**Our Ref** IM/SolumRedhillNew.1  
**Your Ref** 23/00572/F

### Redhill Station

We have in this letter set out a response to the points raised in the Active Travel England (ATE) response in relation to the above project, dated 28<sup>th</sup> July 2023 (reference ATE/23/00268/FULL).

Figure 3: Proposed Development

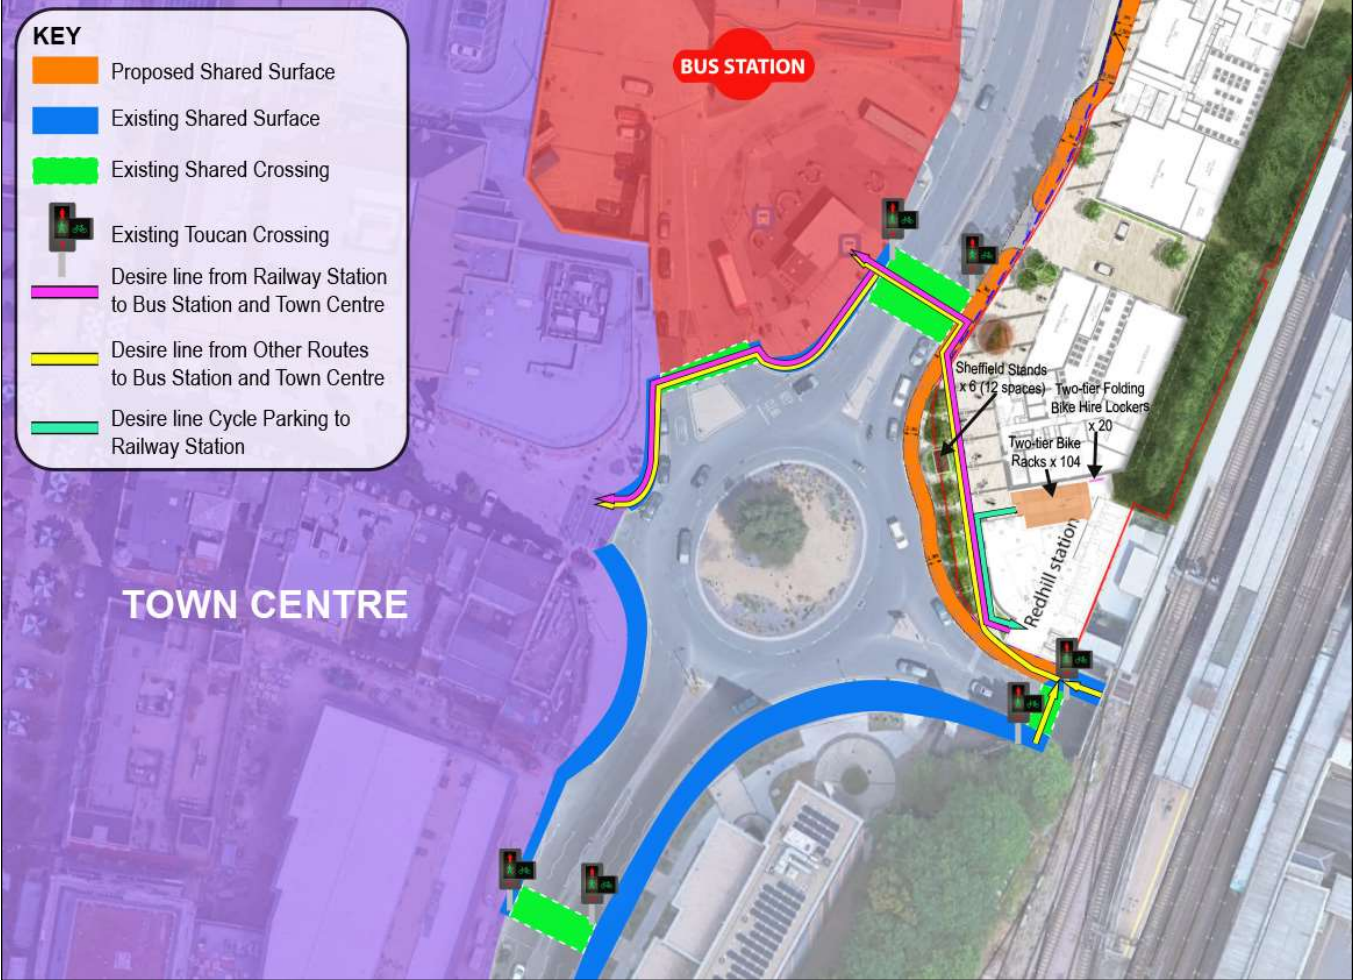
*With the above aim in mind, there are significant opportunities here to improve the existing cycling and walking infrastructure. It is noted that the applicant proposes to extend the existing shared path beyond the toucan crossing on Princess Way, however the applicant does not appear to have provided the existing and forecast cycle and pedestrian flows in order to justify the evidence for this approach. It is considered that these could be significant at certain times*

*given the frequency of trains from Redhill to locations such as central London and Gatwick; this could have an impact on whether a shared surface on Princess Way is considered appropriate, particularly as there is the potential for conflict between pedestrians and cyclists, for example in potential pinch point locations where pedestrians will gather to wait to cross the roundabout. It may be that additional space for a fully segregated cycle route is required in order to manage this conflict.*

*The pedestrian and cycle route to and from the town centre to the west encounters a large roundabout which presents a significant barrier; it is also considered that the proposal makes little attempt to address this or enhance connectivity with the bus station, which is located on the opposite side of Princess way. Further consideration is needed here given the proximity of the site to the town centre and the strong potential to improve external linkages and public realm. The LPA should consider - in conjunction with the Local Highway Authority - whether it is appropriate for this proposal to contribute to any wider off-site highway improvement schemes in this respect.*

The development completely opens up this area as shown in **Figure 3**, providing:

- A direct desire line route from the Toucan crossing to the enhanced station entrance.
- The route also provides direct pedestrian route through to Redstone Hill.
- A shared surface of a minimum of 2.5m along this section in addition to the pedestrian route.

It is noted that 5.3 of LTN1/20 shows that 2.5m shared surfaces could accommodate cycle flows in excess of 300 per hour. It is clear with reference to Figure 3 that users of the station cycle parking would not need to use this section of cycle route, so combined with the comparison with the parallel pedestrian route it is a substantial increase in capacity at this locality.

We don't share this view. The proposals provide a substantial improvement in accessibility between the town centre, bus station and station. Not requiring users to cross the roundabout. This was shown in **Figure 3**.

**Figure 4: Redhill Station Plan**

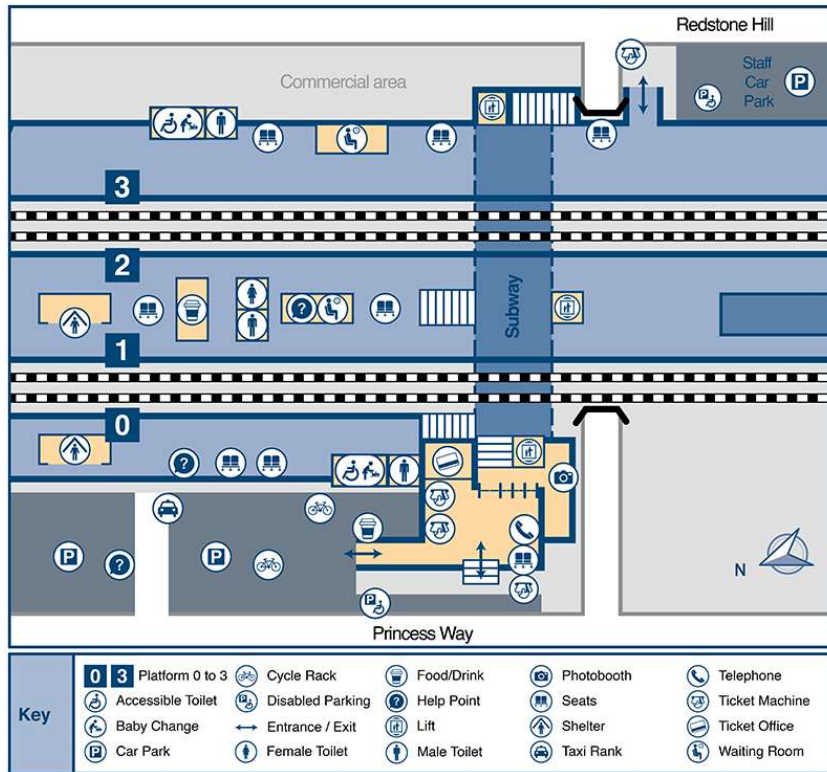
*Clarification is required for the provision of level access to the existing pedestrian subway connecting the sites and increase ease of use for wheelchair users and cyclists.*

Mobility impaired provision is provided the station entrances to the platforms as shown in the Redhill Station Plan in Figure 4.

The development proposals provide upgrades to the station entrances on both Site A and Site B, including for gate line adjustments which include for wide gates suitable for mobility impaired users. As discussed earlier in this letter, the proposals also create a step-free route between the Toucan crossing on Princess Way and the Site A station entrance.
